Crowcon Technical Note

|	
Document Reference:	**GEN117**
Document applies to:	**C02136/AMBER & C02136/RED**
Release Date:	**31st May 2024**
Subject:	**Sonos Klaxon Sounder Beacons (Issue 2)**

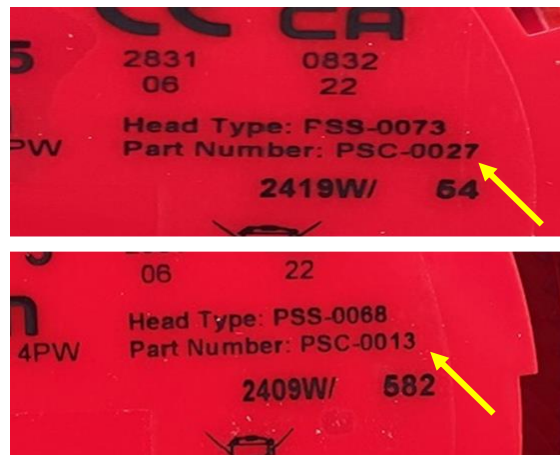
Between June 2023 and Feb 2024, Sonos made a change to the functionality of their Klaxon Sounder/Beacon. The sounder and beacon have been linked internally, meaning that that the sounder was no longer mutable on its own, leaving the beacon still flashing.

The two versions look almost identical. The only way to confirm which model you have is to check the Part Number printed on the inside of the device.

Incorrect (not for Gas Detection)
Crowcon Part Number:
C02136/AMBER - PSC-0042
C02137/RED - PSC-0049

Correct (for Gas Detection)
Crowcon Part Number:
C02136/AMBER - PSC-0027
C02137/RED – PSC-0013

The "PSC" Number can be found in this area

Because this functionality is closer to how Fire Alarm systems operate, Crowcon have reverted to the original design, which is more in line with the Gas Detection Industry.

If you have the incorrect part and this does not suit your application please contact Crowcon for a replacement.
